Space House

Non Material Amendment Document

For Seaforth Land

2.0 Demolition scope update

Fig. 2.1.3 Proposed Amendments to Consented Elevation

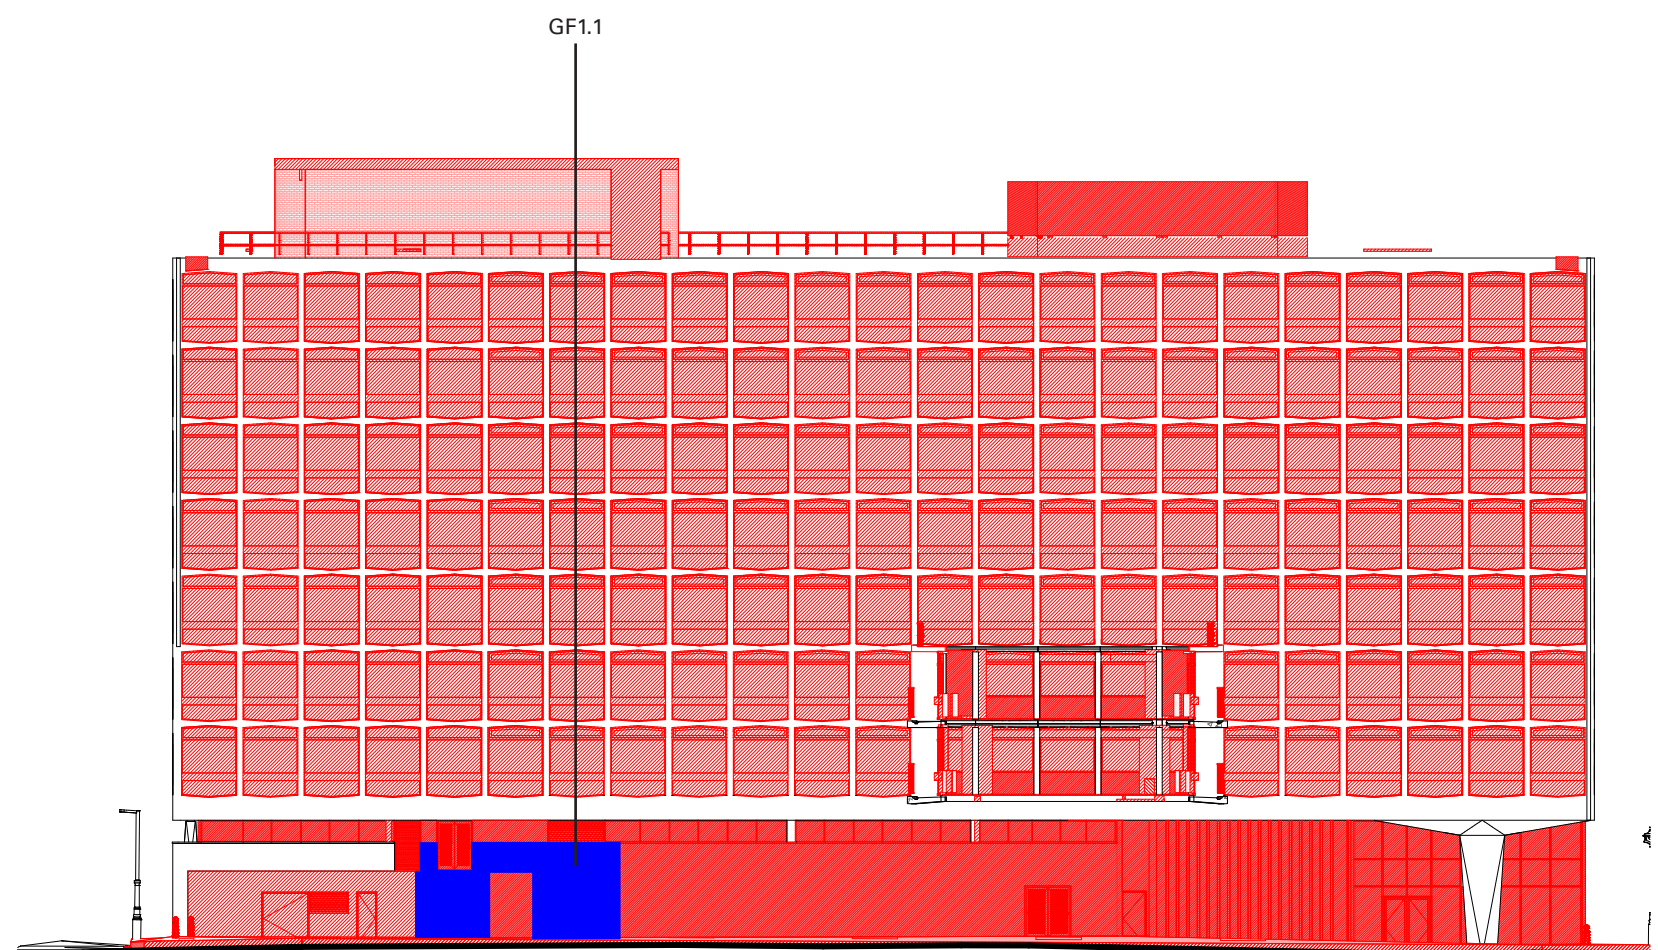
Upon strip out of the area, the consented lift shaft wall is located closer to the facade than anticipated. In order to construct the consented lift shaft, the existing brickwork facade (GF1.1 on Fig 2.1.3) is required to be demolished to allow for formwork of the concrete lift shaft.

The existing brickwork wall is formed by 2no. layers of brickwork. It is evident (once stripped back) that the inner face of this wall is in poor condition; made of patchwork of brickwork and blockwork and structurally precarious. For this reason, the structural engineer recommends that this wall is rebuilt entirely.

GF1.1 -The proposal is to is to remove this brickwork facade and rebuild it in the same place using the existing brickwork.

The planning officers requested details for the methodology of removal of bricks to the area to ensure that the amount of brickwork to be reinstated could be maximised. The main contractor methodology is highlighted in page 7.

Fig. 2.2.2 Proposed Level 07 Demolition Plan

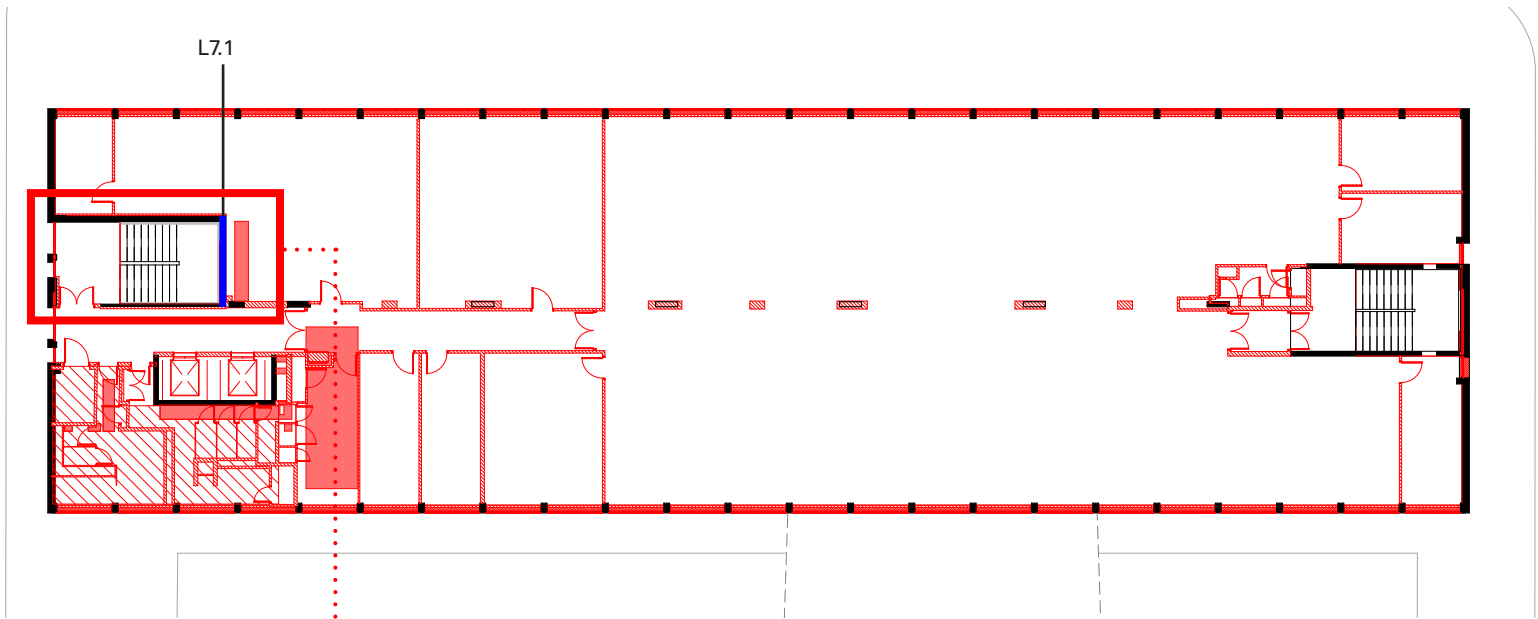
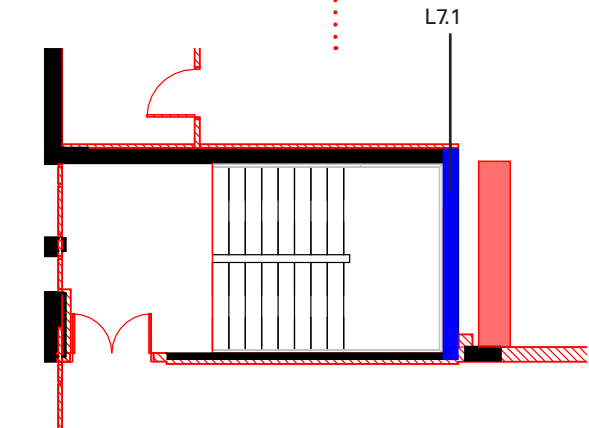
L7.1 - Existing blockwork wall to be removed to allow for new steelwork to support the consented stair. New wall to be rebuilt in the same location of the existing wall. This wall separates the service riser and the existing stairwell. The wall on the stairwell side will be finished to match existing.

See Fig. 2.2.2 and 2.2.3 for additional demolition location.

| 18077-SQP-ZZ-07-DP-A-PL01012 | E | |

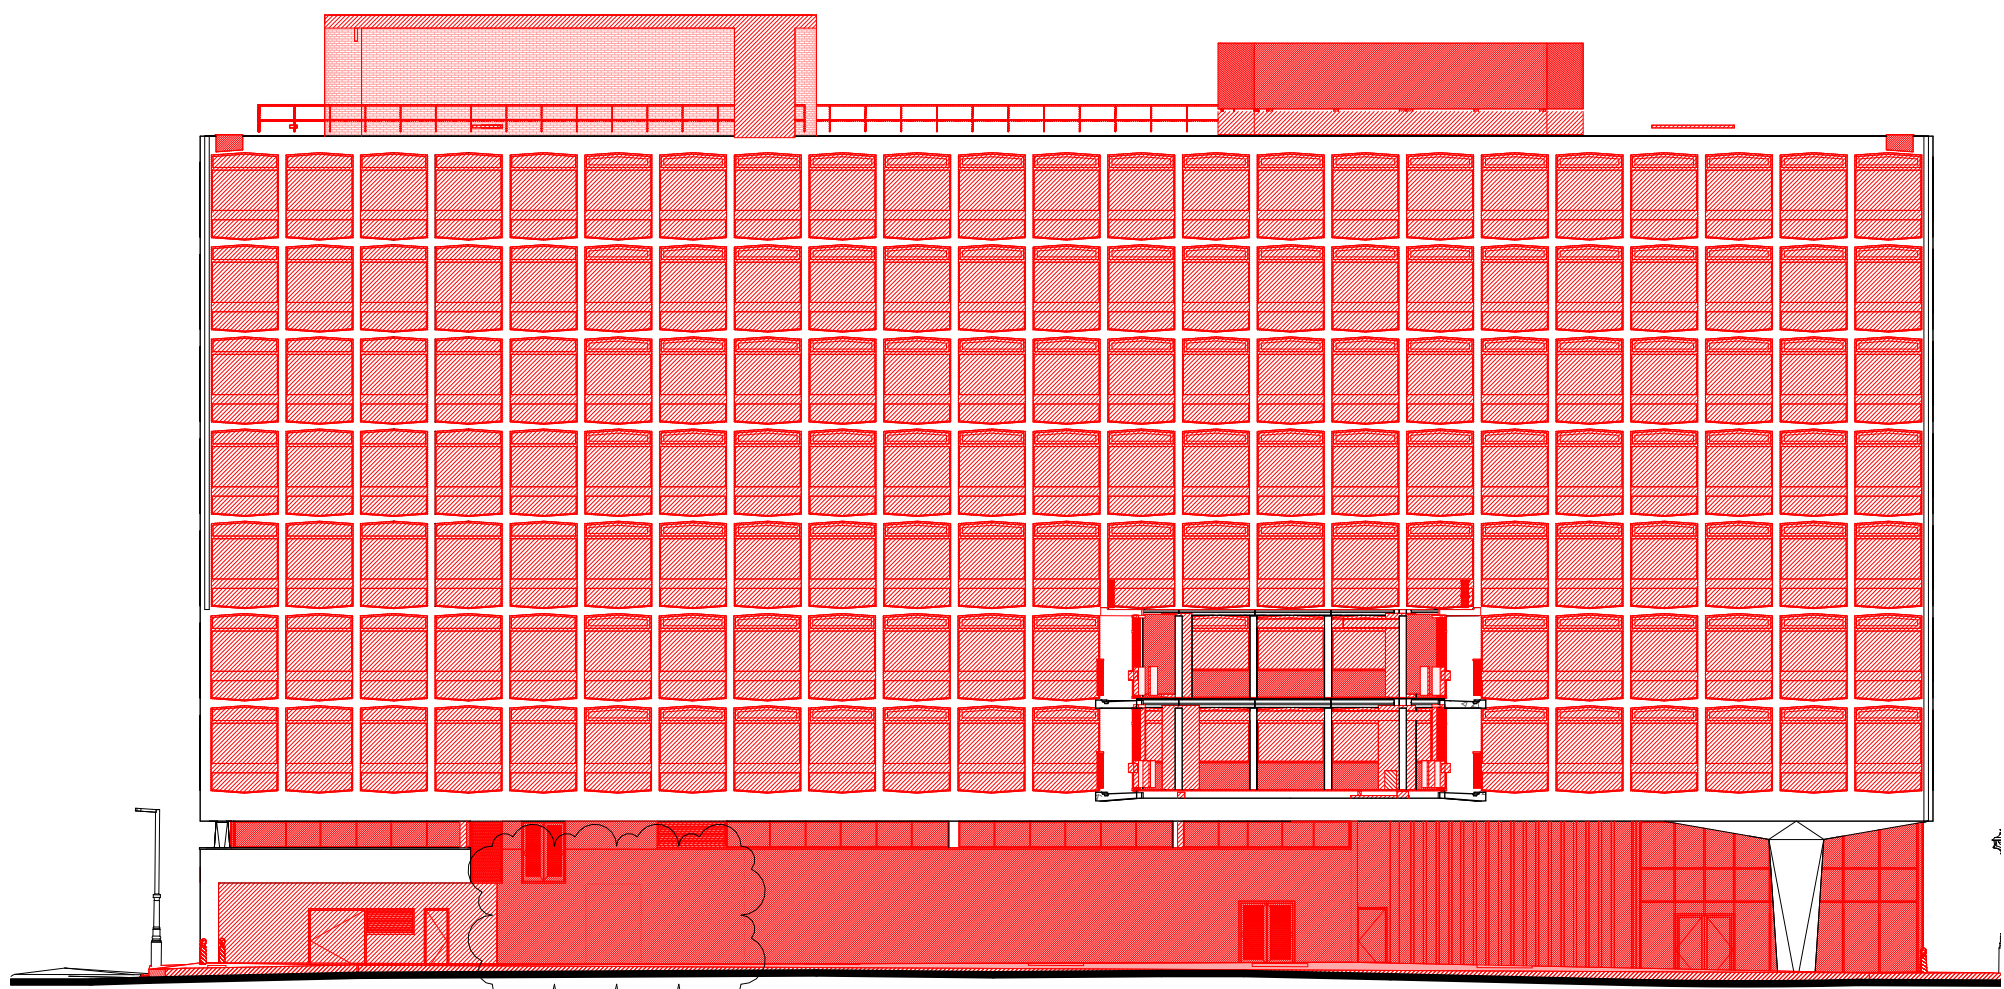
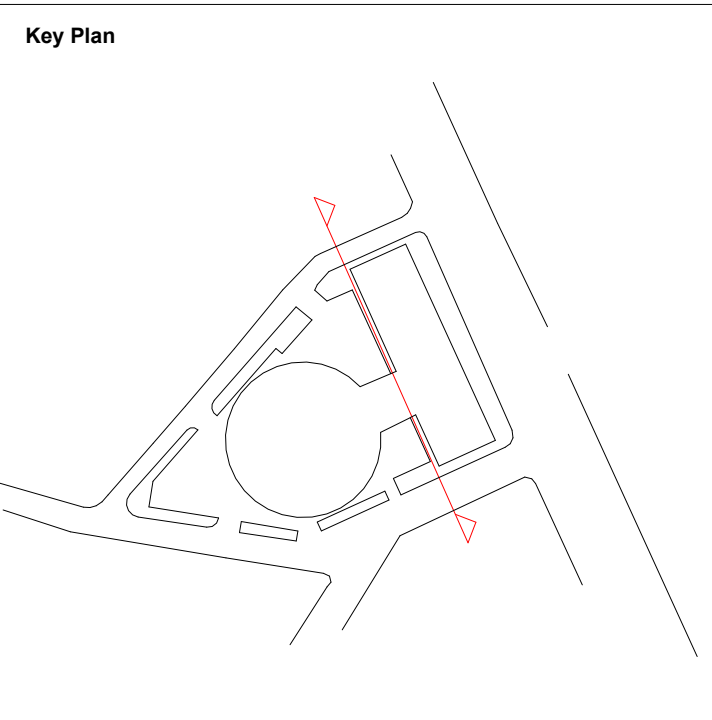
Brickwork at face of existing RC beam to be removed to allow new RC beam to be connected

Brickwork to be removed down to the top of existing RC beam level
